MANDATORY SERVICE BULLETIN

MSB18-08B

SUBJECT: Inspection and Maintenance Modification of Cylinder Assemblies

PURPOSE: To inspect and remove casting material build-up on the radius edge of identified cross-flow cylinder heads.

Figure 1. Affected Cross Flow Cylinders, Top Fin Flange typical

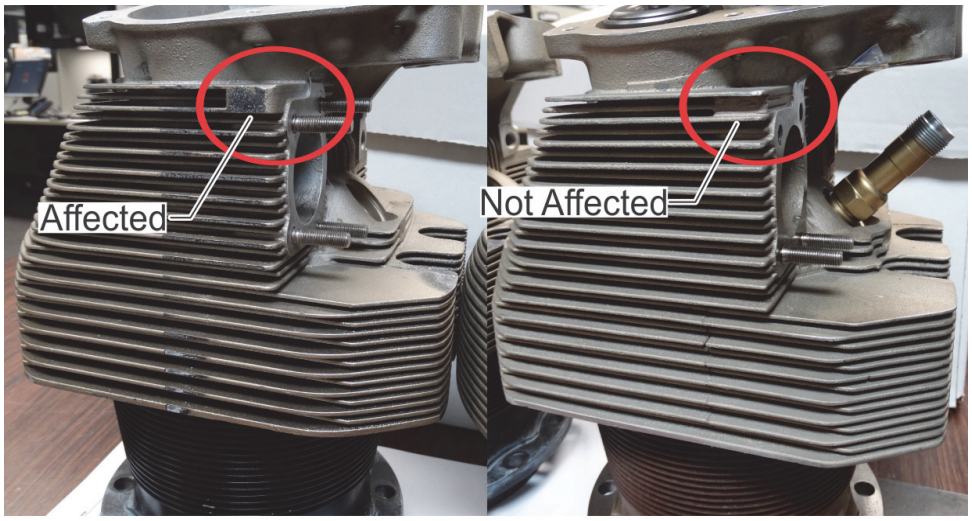
Several field reports indicate the potential for fracture initiation on engines (exceeding 500 hours of operation) at the radius edge of identified cylinder heads produced on or after 01 NOV 2014 (see Figure 2). The affected cylinder casting can be identified by the "filled" top fin flange area above the exhaust port as shown in Figure 1.

This service document is issued to provide inspection criteria and perform corrective action on affected cylinder assemblies. Affected cylinder head castings have a distinguishing feature (see Figure 1) from unaffected. Affected new and rebuilt engines with serial number 1036883 and later were inspected and corrected at the factory to comply with this Service Document. Additionally, all cylinder heads stamped with the letter **"S"** (regardless of serial number) meet full compliance and do not require additional inspection, see Figure 3.

Figure 3. Cylinder Head Indicates Prior Compliance, Stamped with Letter “S”

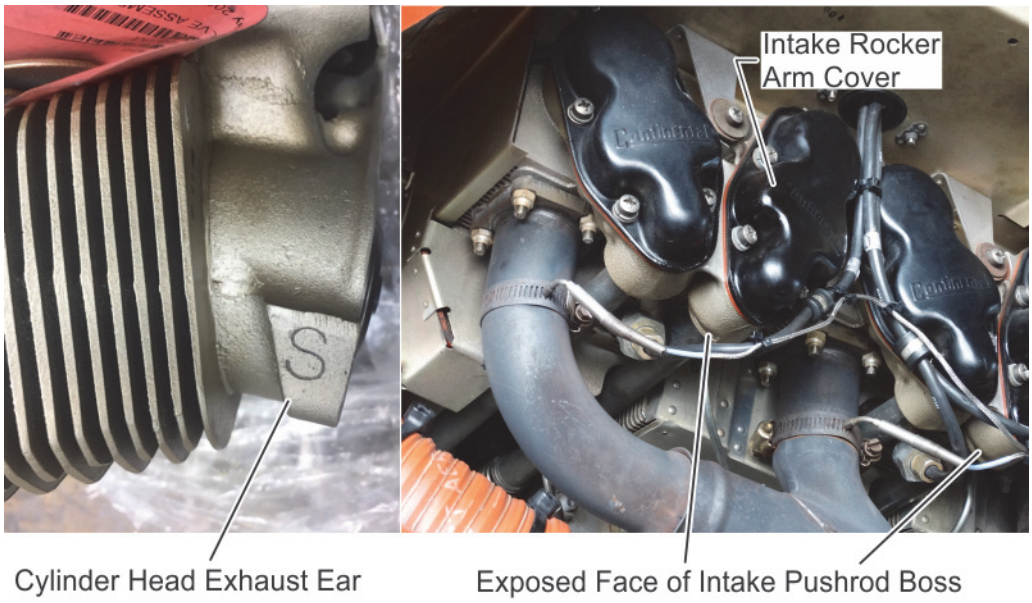
1. The cylinder head meets compliance with Service Document (MSB18-08) if:
   a. Serial number AC-18KB277 or later (reference Figure 9), *or if*
   b. The letter “S” is metal stamped on either the cylinder head exhaust ear or on the exposed face of the intake pushrod boss, (reference Figure 3)**,** *and if*
   c. The radius corner inspection and modifications were completed in accordance with this Service Document (reference Figure 4).

6. Metal stamp the letter "S" (1/4" stamp) on the face of the intake pushrod boss (reference Figure 3) to indicate part compliance.
7. Use compressed air and a clean dry rag to remove residual material.

Figure 4. Smooth Radius Corner after Radius Blend Modification

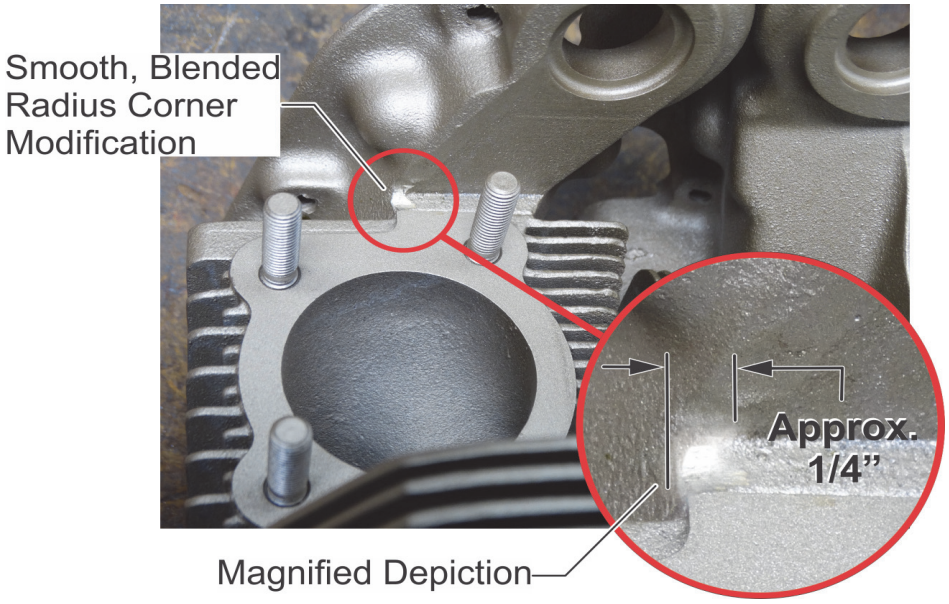
2. If the cylinder head exhaust ear is not stamped with the letter “S” or is obscured by baffling, inspect the radius corner angle below the exhaust port (see Figure 5) for any casting flash build-up or sharp radius edges. The radius corner should be tapered and blended smooth (reference Figure 4).

Carefully, vary your filing motion until a smooth, blended "tapered" radius edge is achieved at the radius corner. Remove ONLY enough material from the cylinder head to achieve dimensional specification, see Figure 4. The finished radius blend should not exceed 0.20" depth of the material removed.

5. Inspect the cylinder head surface and remove all nicks, burrs, sharp angles or edges using a de-burring tool and Scotch-Brite© (ultra fine or equivalent). Evenly shape, taper, and smooth all interfering surfaces where material was removed (see Figure 4).

Figure 6. Cylinder Head Radius Corner, side view

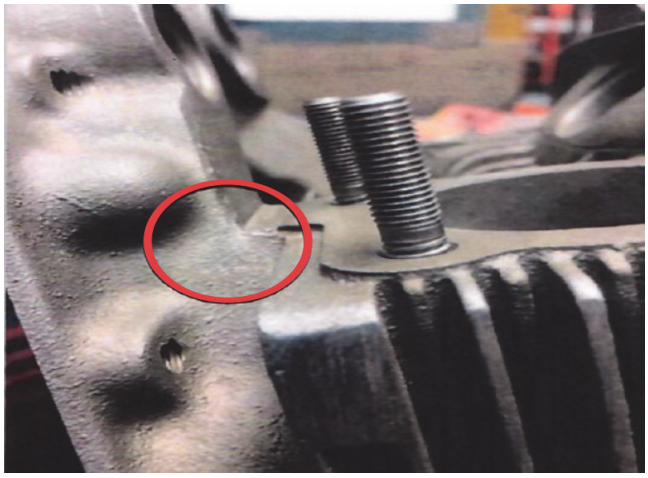
3. Perform a "Non-Destructive Visual Inspection" according to the latest instructions in M-0, Standard Practice Maintenance Manual, Chapter 11, on the cylinder head radius corner (all possible angles). All cracks require attention, regardless of size or location. If a fissure, crack or physical damage is identified, replace the cylinder. Contact Continental Customer Service (Section V on page 6) to order replacement parts.
